**TOWNSHIP OF SOUTH WHITEHALL
LEHIGH COUNTY, PENNSYLVANIA**

**C. PROPOSED COMMERCIAL DEVELOPMENT 1810 PA ROUTE 309
MAJOR PLAN 2020-103**

TO: PLANNING COMMISSION
FROM: GREGG ADAMS, PLANNER
**SUBJECT: PROPOSED COMMERCIAL DEVELOPMENT 1810 PA ROUTE 309
MAJOR PLAN 2020-103
REQUEST FOR PRELIMINARY/FINAL PLAN REVIEW**
DATE: DECEMBER 13, 2021
**COPIES: BOARD OF COMMISSIONERS, R. COPE, D. MANHARDT, L. HARRIER,
D. TETTEMER, L. PEREIRA, ESQ., APPLICANT, SUB. FILE 2020-103**

RE: 1810 PA Rte 309 Convenience Store Land Development Plan
SWT Major Plan # 2020-103

SHEET NUMBER:
C-301

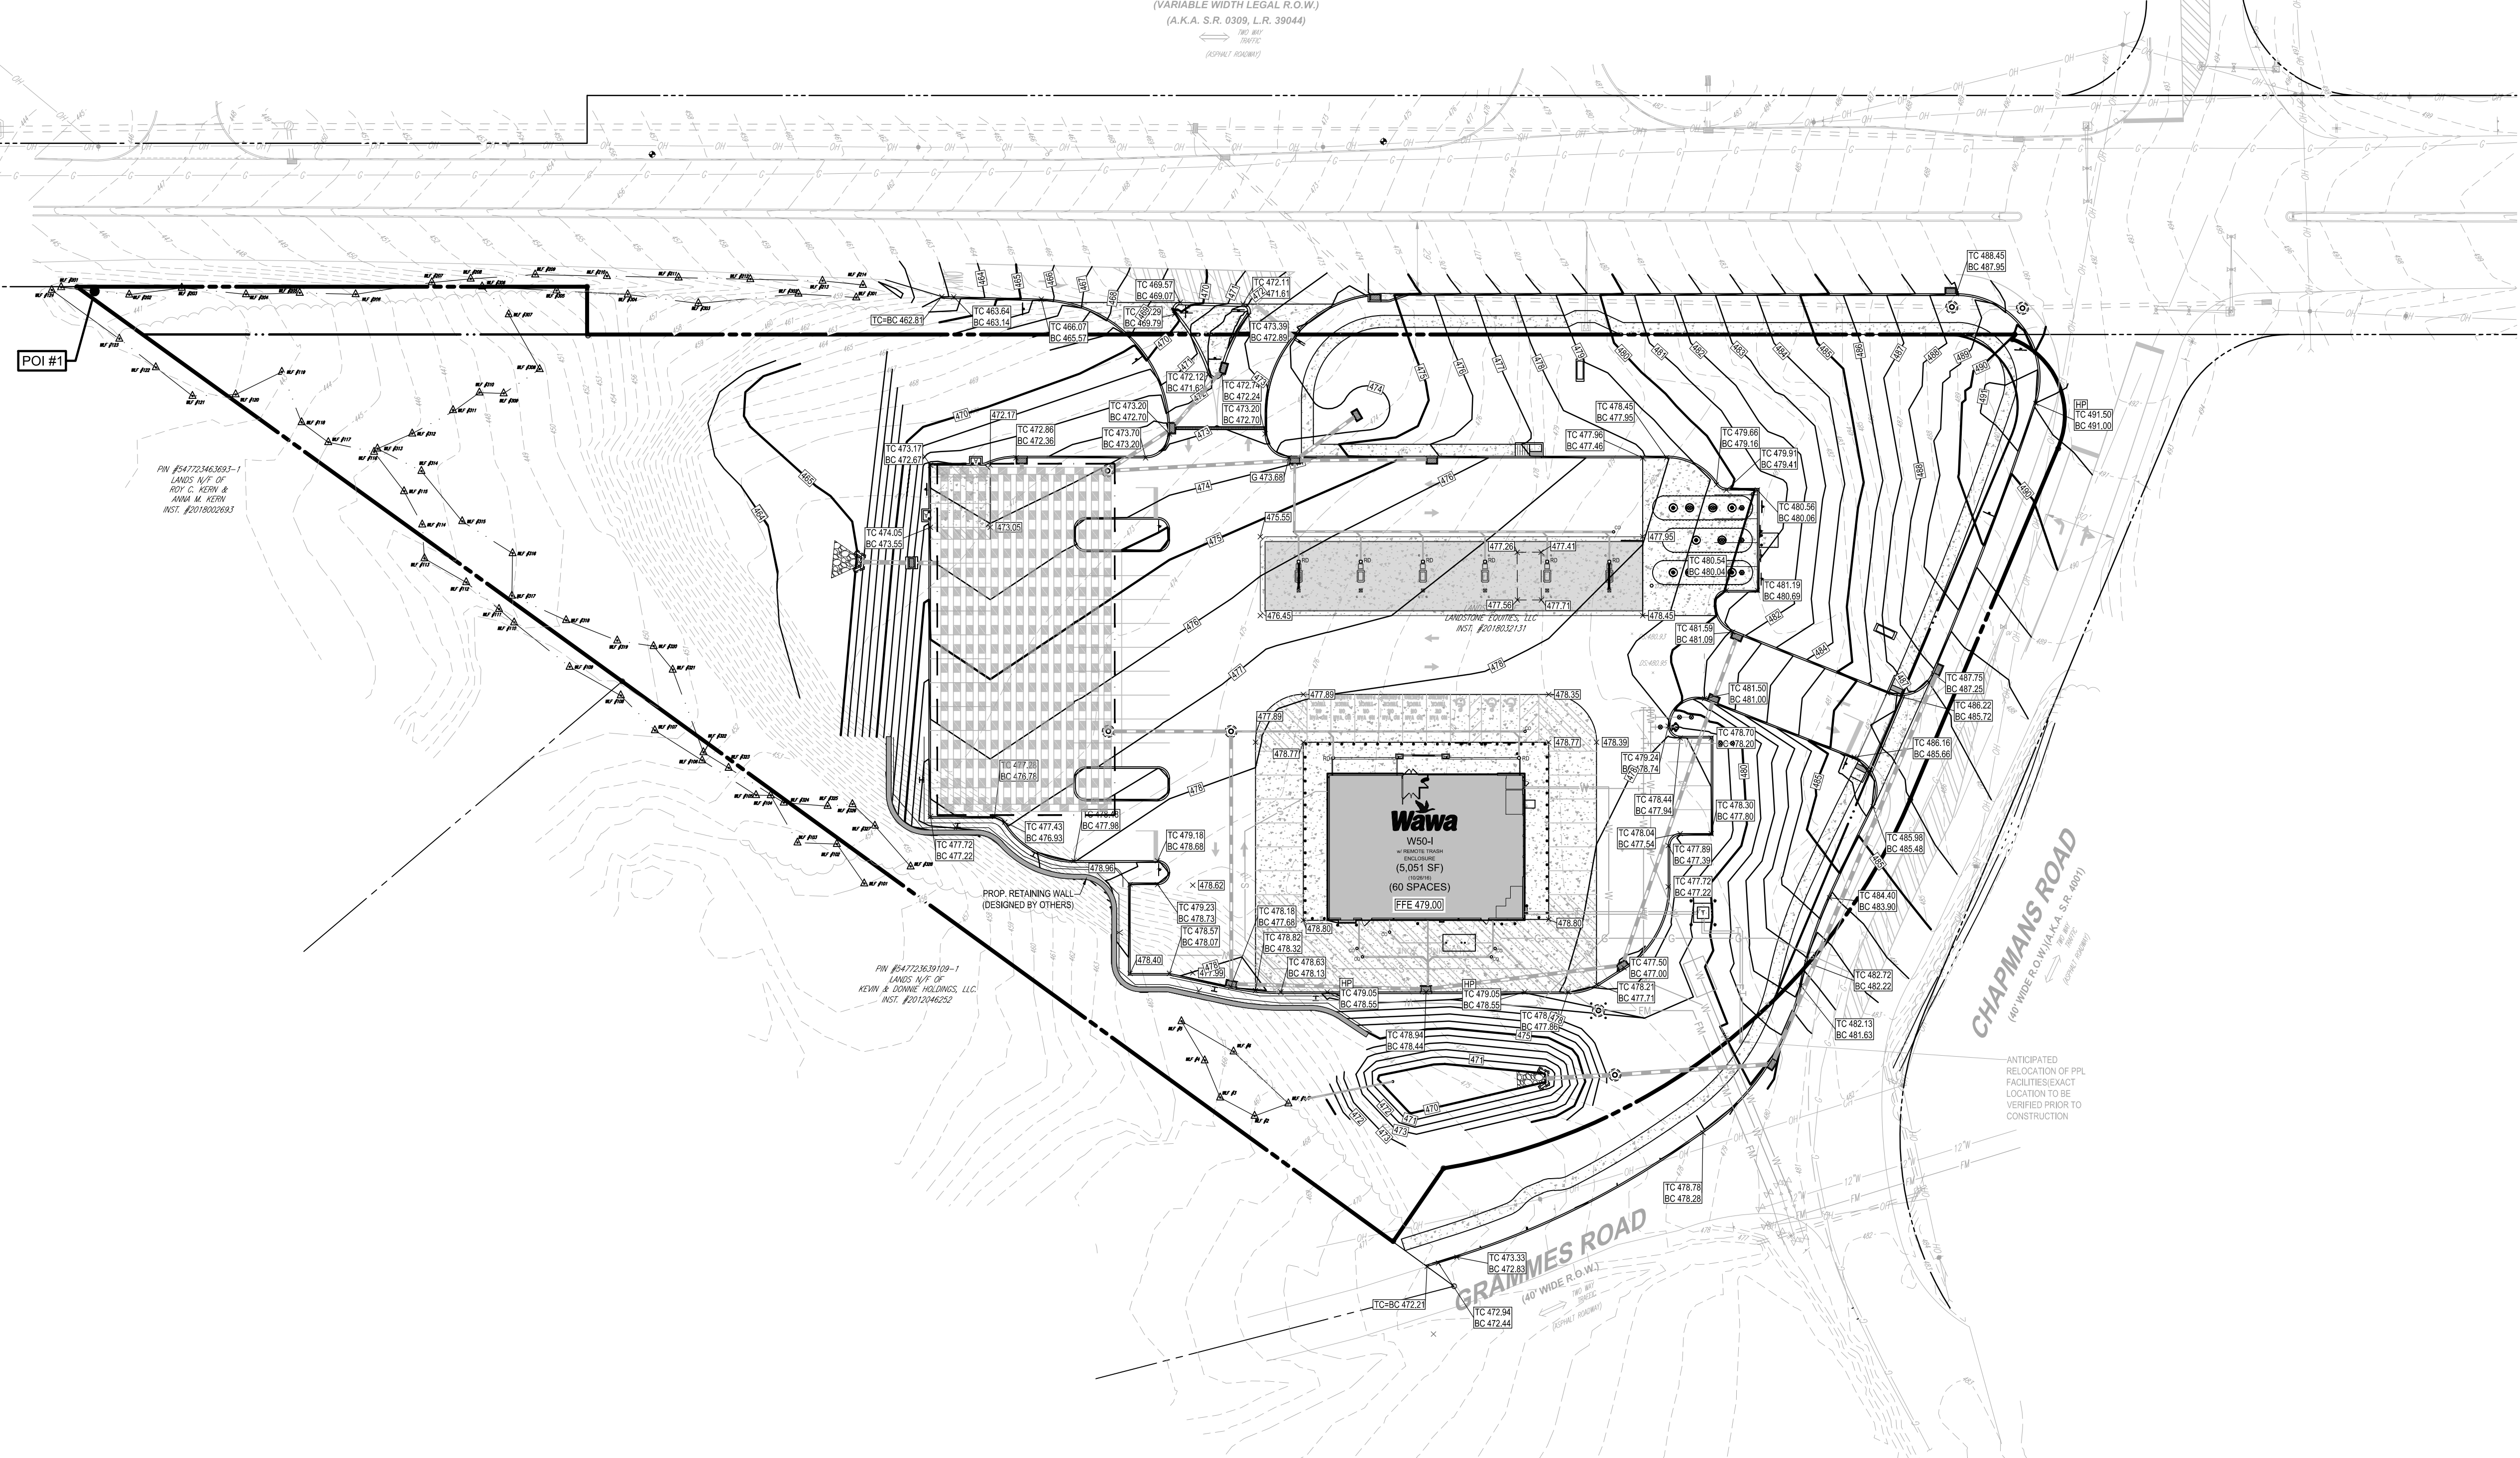
- J. **Parks and Recreation Board** – At their September 14, 2020 meeting, the Parks and Recreation Board recommended that the developer pay fees in lieu of common open space land dedication to meet the open space and recreation requirements of Section 312-36(d)(4) of the Subdivision and Land Development Ordinance. For nonresidential developments a fee shall be Twenty-Five Cents (\$0.25) per square foot of additional impervious coverage (post-development impervious surface minus pre-development impervious surface) in lieu of the requirement for public dedication of land. The fee in lieu of Open Space dedication has been calculated to be \$16,800.00, based upon the Zoning Requirements block on Sheet C-301.

7. The Site Plan proposes internal access drives and fueling pumps located immediately adjacent to the proposed right in/out driveway along the site's Route 309 frontage. This condition could result in several negative consequences including but not limited to the blocking of the SR 309 inbound traffic due to vehicles attempting/waiting to access the fuel pumps and/or due to the potential for the inbound lane to be blocked by the outbound queue of vehicles waiting to turn right onto southbound SR 309 (especially during peak traffic conditions when the southbound queue at the SR 309 & Chapmans Road intersection could block the right-out driveway). In light of this, consideration should be given to reorientation of the site layout to preclude or alleviate these conditions. The Developer should consider providing an internal clear sight triangle at the proposed stop sign adjacent to the right turn in driveway and along the right turn in driveway meeting Penn DOT to guarantee safe sight stopping distance.

GRADING PLAN

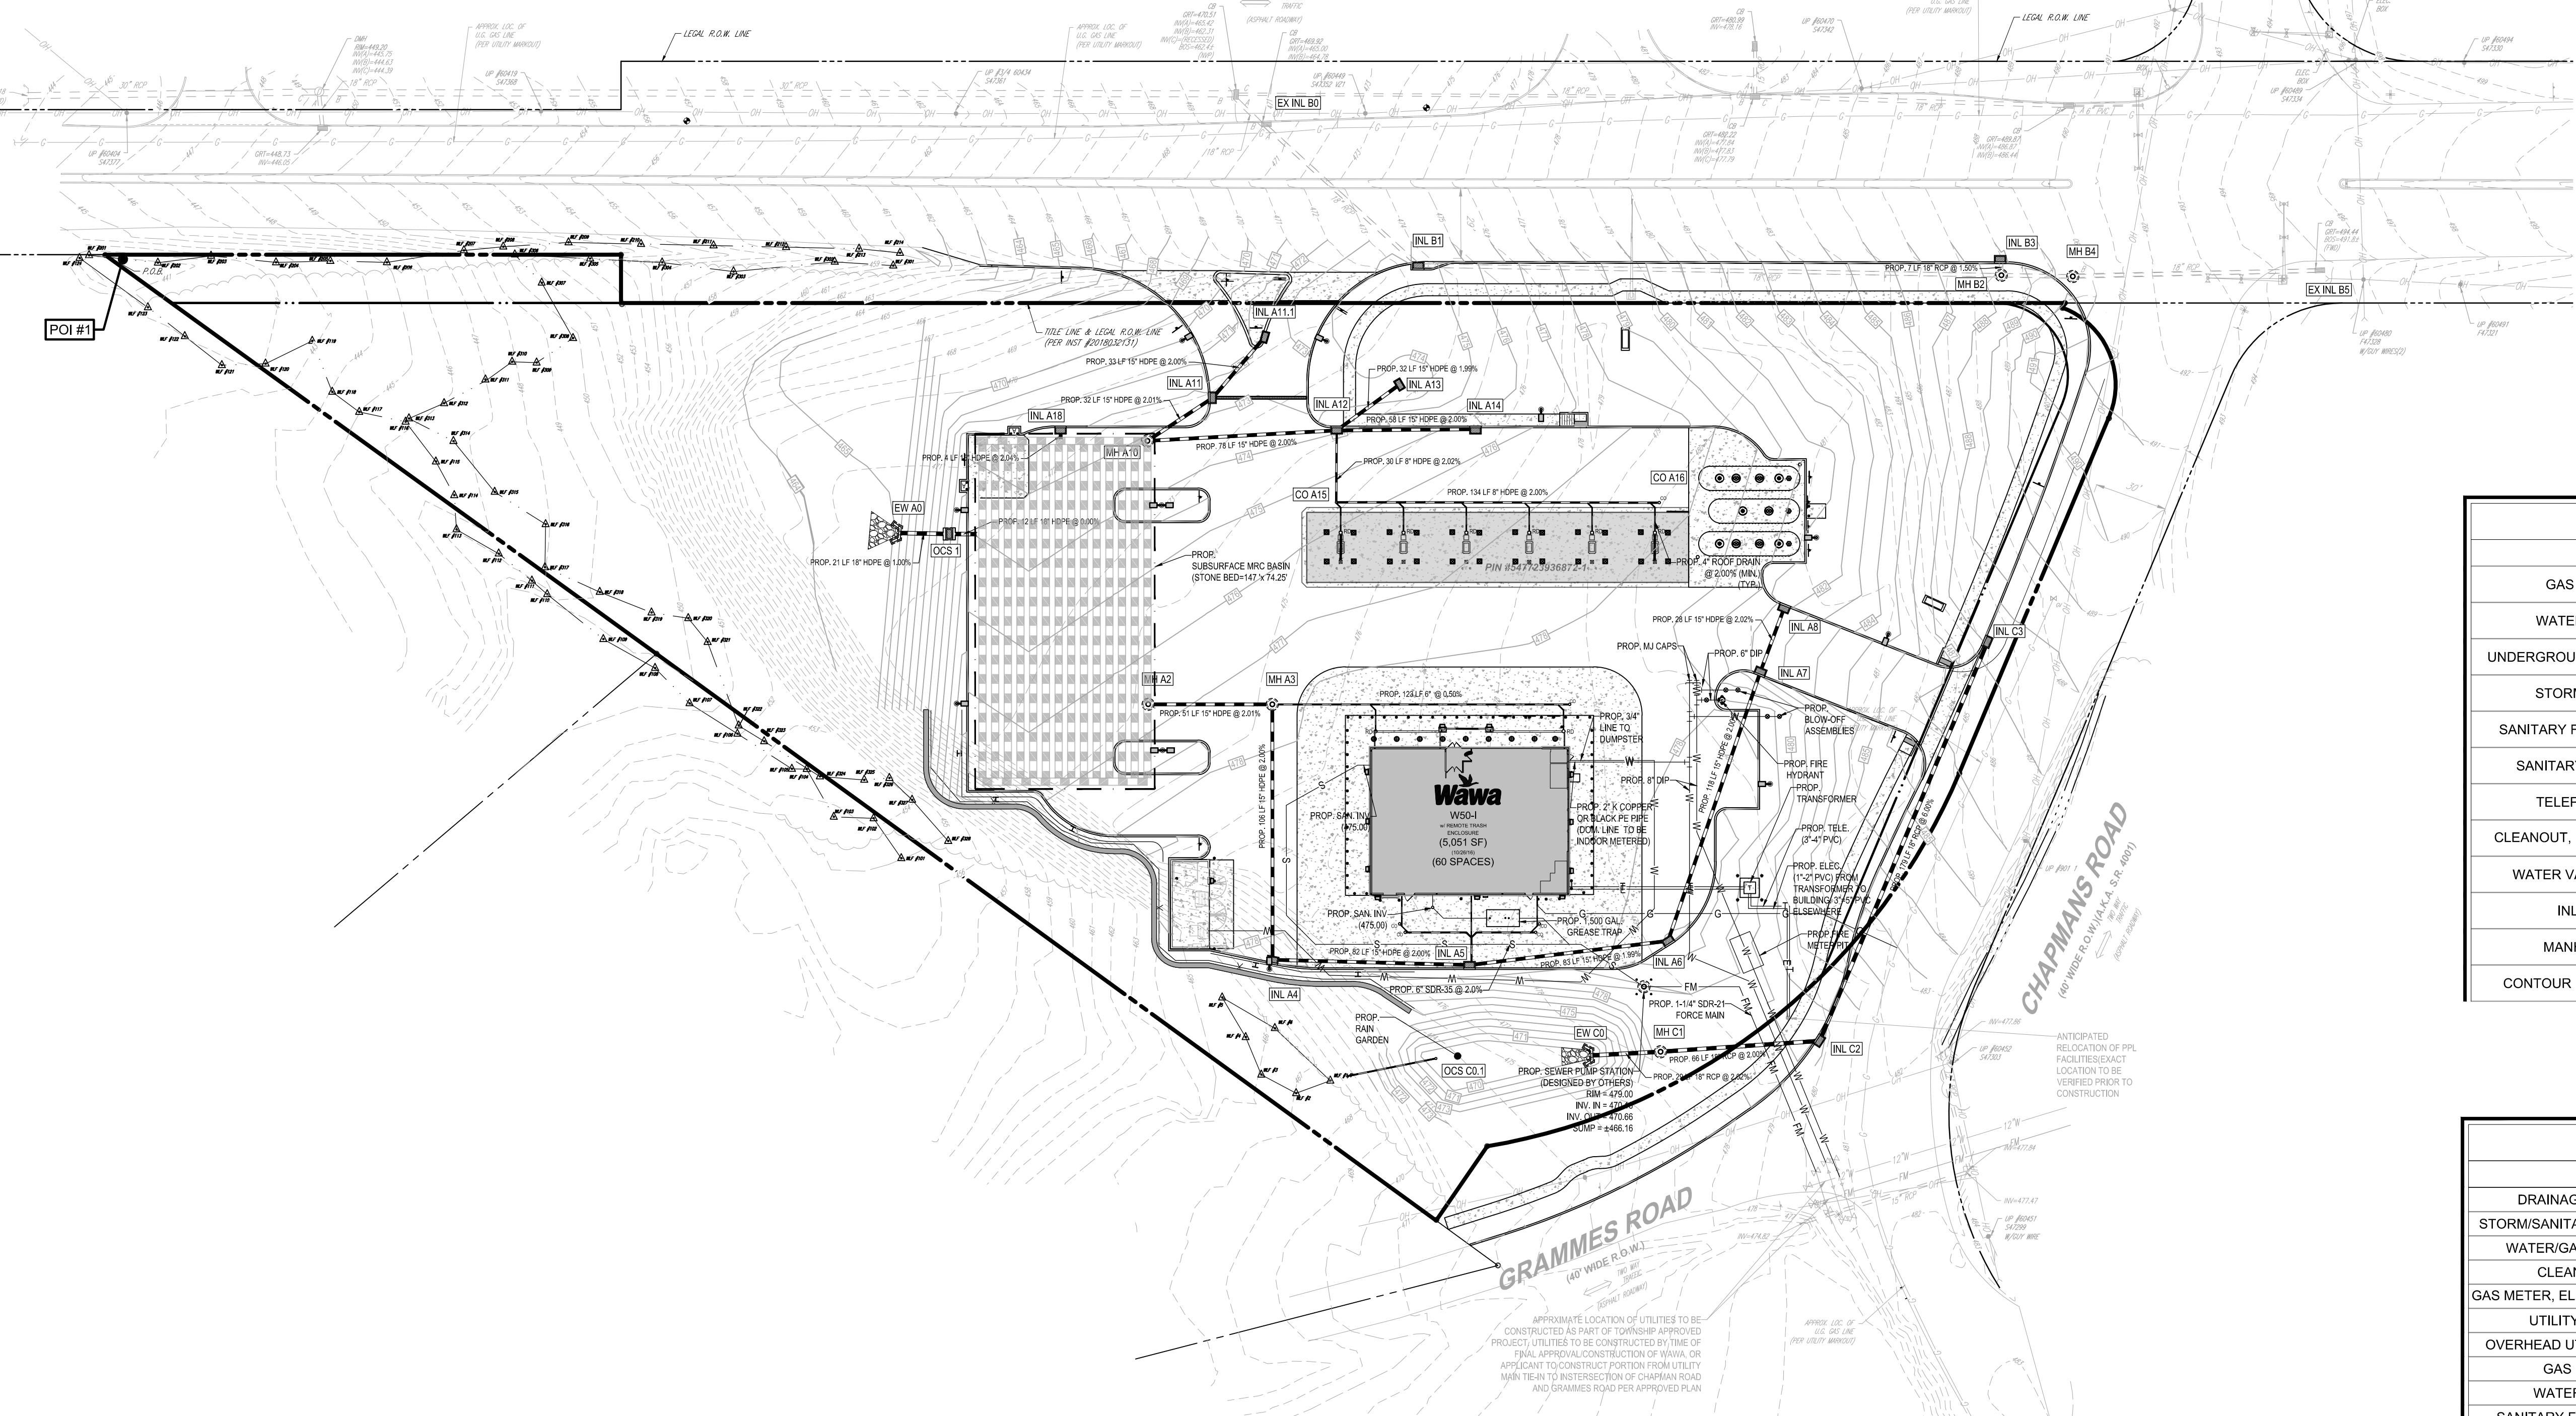
6. The Grading Plan indicates grading that would direct storm water runoff onto the cartway of Route 309 at the proposed right-in/right-out driveway. The grading in this area should be revised to direct the runoff to flow along the curb channelizing island.
